February 16th, 2024

Site: 1385 Hillside Circle, Burlingame, CA

NEW RESIDENCE
1385 HILLSIDE CIRCLE LOT 1
BURLINGAME, C.A.
A.P.N.: 000-000-000

ARBORIST REPORT

Showing portion of driveway recommended to be retained until the landscape phase of the project

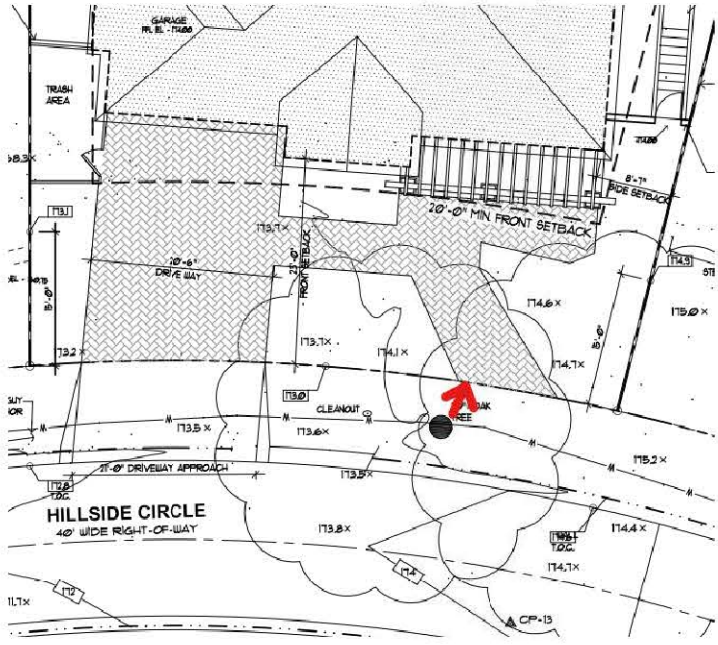
Impacts/Recommendations:
Oak tree #1 is to be retained. The tree is adjacent to an existing driveway. It is recommended to temporarily retain the existing driveway near this tree when underneath the dripline of the tree during the building phase of the project. Temporarily retaining the driveway will act as a tree protection measure and will help to increase staging and access to the site, as removing the driveway at the beginning of the project would make for a larger tree protection zone needed with the fencing being located at the tree's drip line. The existing grade within the tree's dripline is recommended to be retained as is where possible. No grading or excavation is recommended to take place within 10' from this tree (6x diameter) except for the removal of the driveway. At the end of the project, when it is time to demolish the existing driveway near this tree, the Project Arborist is

recommended to be on-site to document and witness the removal of the driveway. A jackhammer is recommended to be used when working within the tree's drip line to break the concrete material into hand manageable-sized pieces. Once broken down the driveway material is recommended to be removed by hand. Exposed roots during the process are recommended to be wrapped in layers of wetted-down burlap to avoid root desiccation. The existing driveway area is recommended to be filled back in once the driveway has been removed so that no roots are exposed to the elements. When backfilling the soil in this area, the area is also to be irrigated. The proposed driveway is further from the tree than the existing driveway and outside of the 10' range and is not expected to have impacts on the tree. The tree is recommended to be deep water fertilized with Nutriroot once the work near the tree has taken place as a mitigation measure for any minor impacts that may take place.

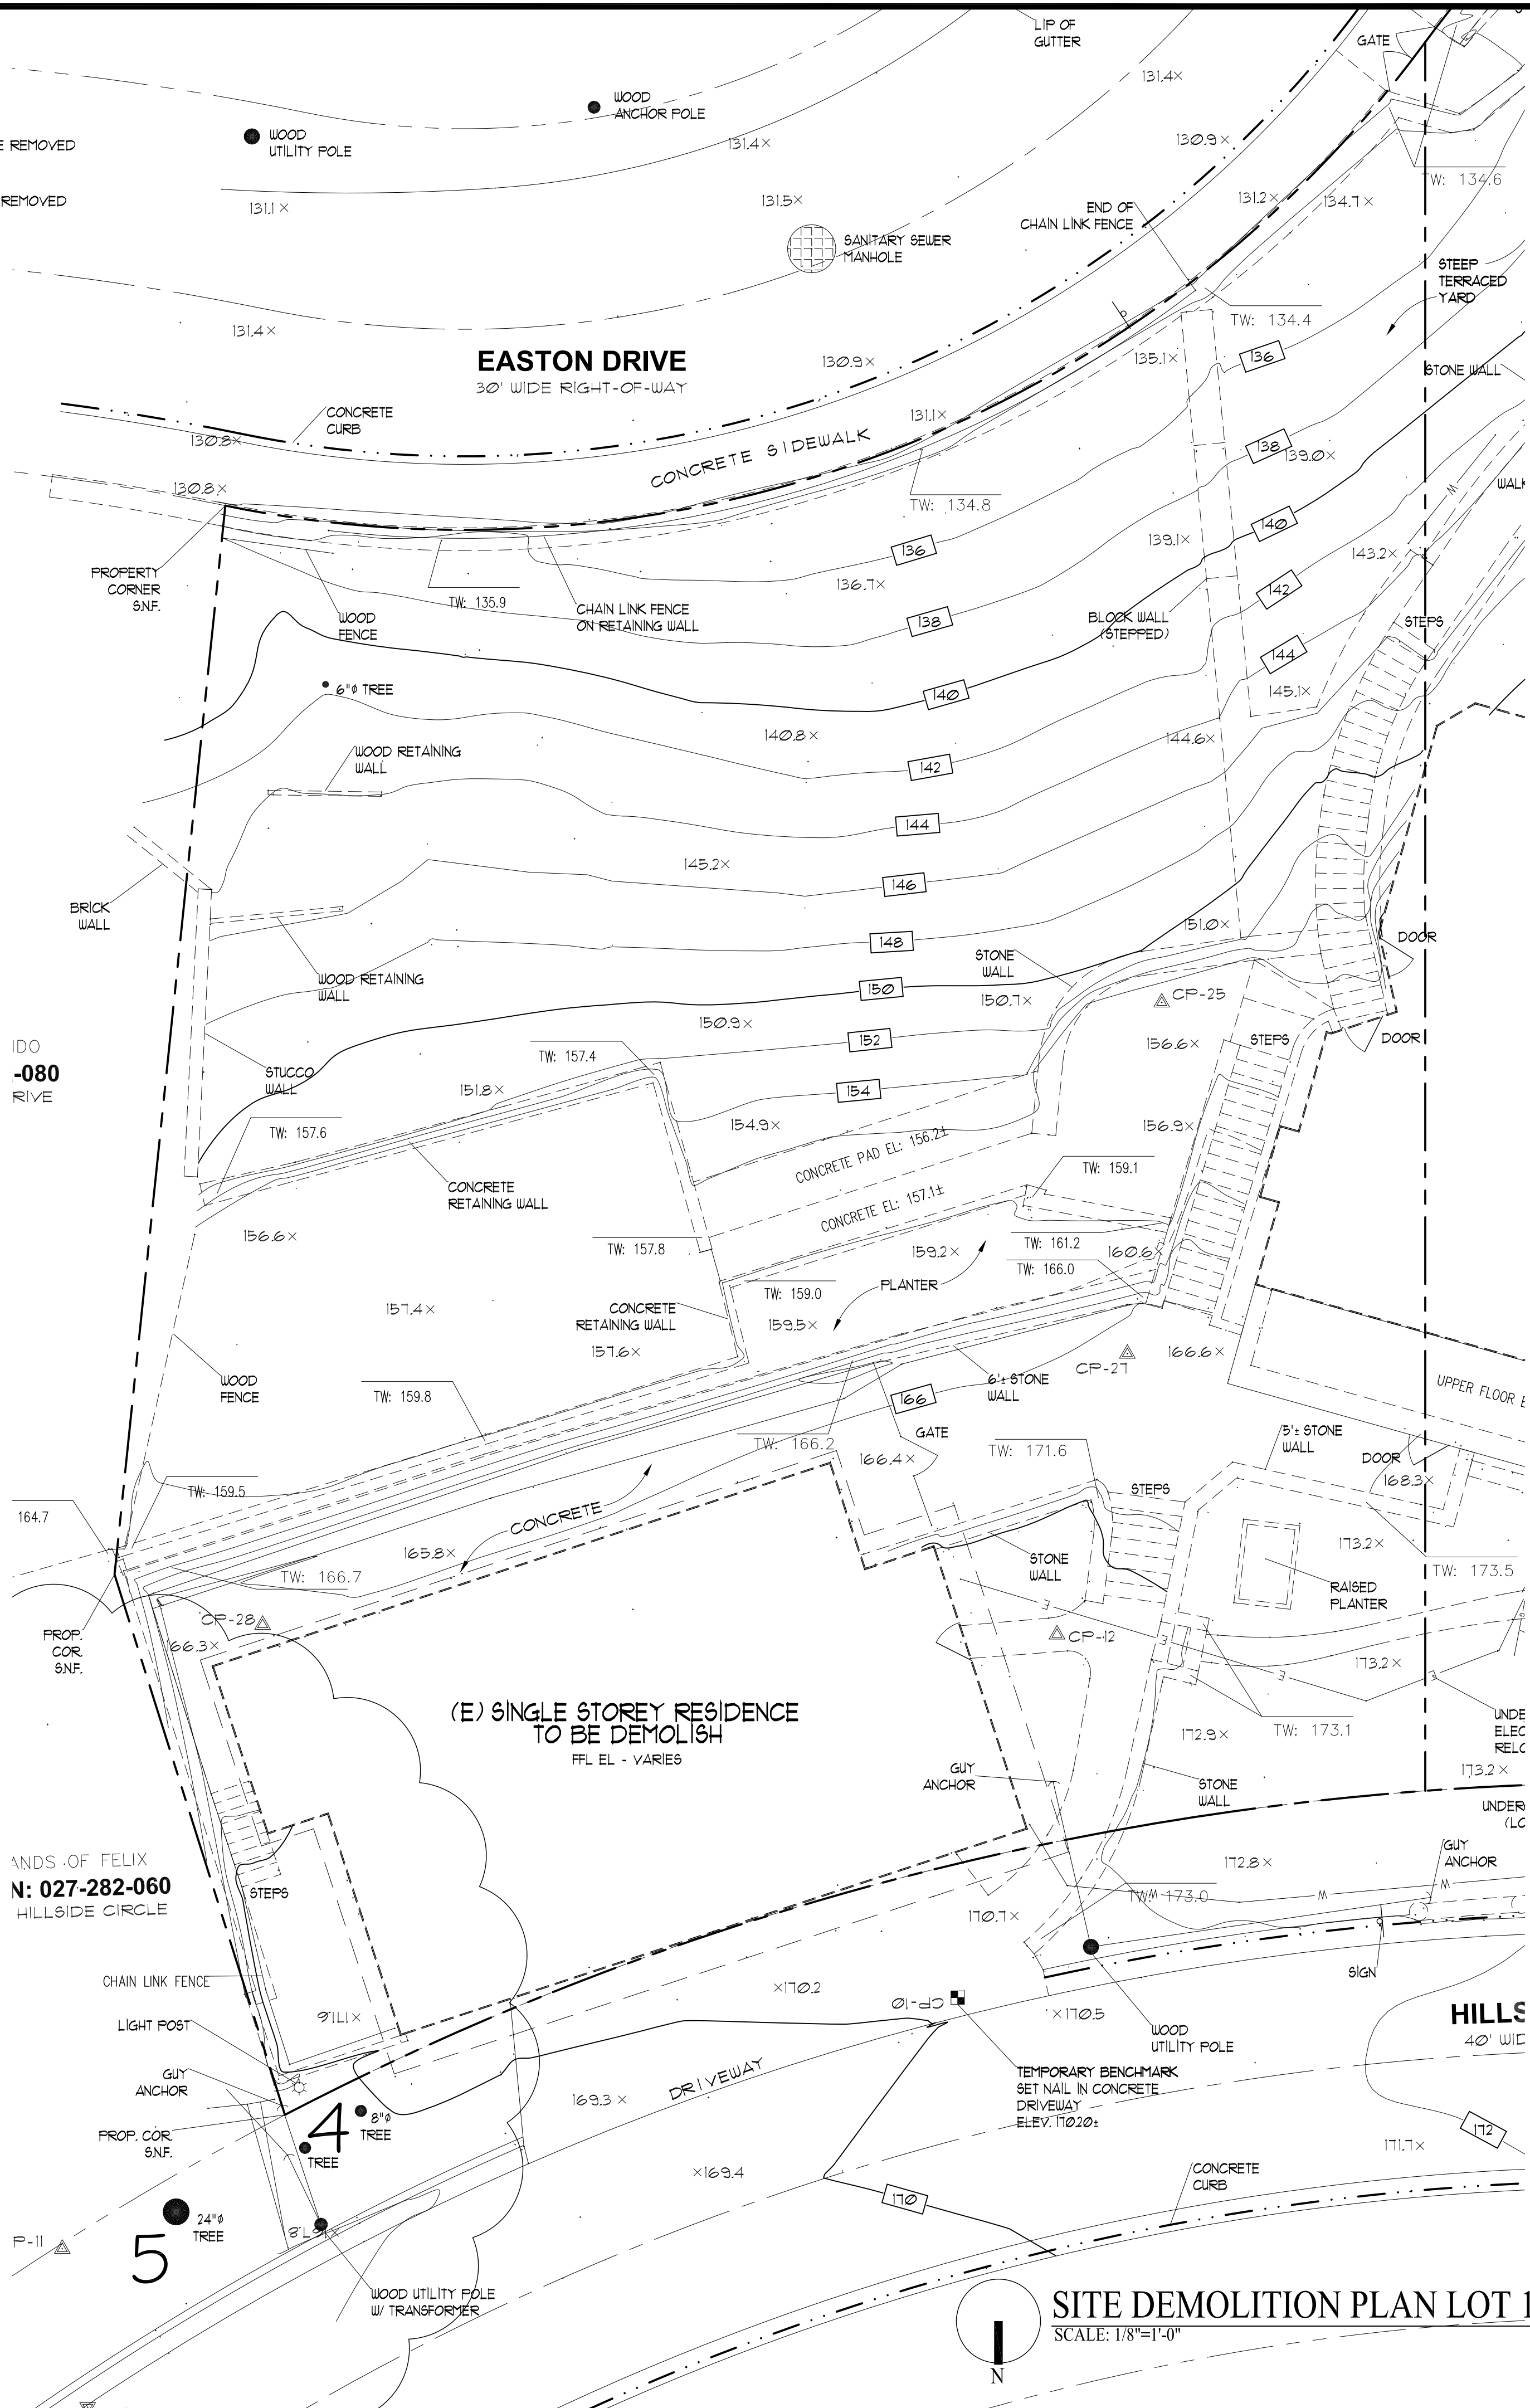
ENSURE THAT TREE PROTECTION SPECIFICATIONS ARE SHOWN GRAPHICALLY ON SITE PLANS FOR CONTRACTOR TO FOLLOW, AS FOLLOWS:

LOCATION OF ALL TREE PROTECTION MEASURES INCLUDING BUT NOT LIMITED TO FENCING, TRUNK WRAP, ROOT BUFFER, ARE TO BE GRAPHICALLY SHOWN ON DEMO PLAN A2 SO THAT CONTRACTOR CAN EASILY INSTALL AND EXECUTE THE TREE PROTECTION MEASURES.

LOCATIONS OF HAND DIGGING AND LOCATIONS OF WORK TO BE UNDER PROJECT ARBORIST SUPERVISION ARE TO BE GRAPHICALLY SHOWN ON THE RELEVANT SITE PLAN SO THAT CONTRACTOR(S) CAN EASILY UNDERSTAND AND EXECUTE THE SPECIFICATIONS. WORK WITH THE PROJECT ARBORIST TO PRODUCE ACCURATE INFORMATION ON THE RELEVANT SITE PLAN. SOME OF THE INFORMATION WILL BE ON THE A SHEETS AND SOME ON THE L SHEETS.

ARBORIST REPORT RECOMMENDS:
RETAINING SOME OF THE DRIVEWAY NEAR TREE 1 AND BREAKING IT DOWN BY HAND LATER IN THE PROJECT. PUT THIS ON DEMO PLAN A2 SO CONTRACTOR CAN FOLLOW IT.
CHANGING THE PATHWAY NEAR TREE 10 TO AVOID ROOT LOSS/DAMAGE. WHERE IS TREE 10? HAS THE PATHWAY BEEN CHANGED?

INDICATE THAT AT LEAST 3 SINGLE-TRUNKED LANDSCAPE TREES WILL BE PRESENT ON EACH LOT, AS NOTED BELOW.

PROVIDE THE BOTANICAL NAME (GENUS AND SPECIES) AND LOCATION OF THE REQUIRED LANDSCAPE TREES, AND WHETHER THEY ARE EXISTING OR NEW, FOR EACH LOT.
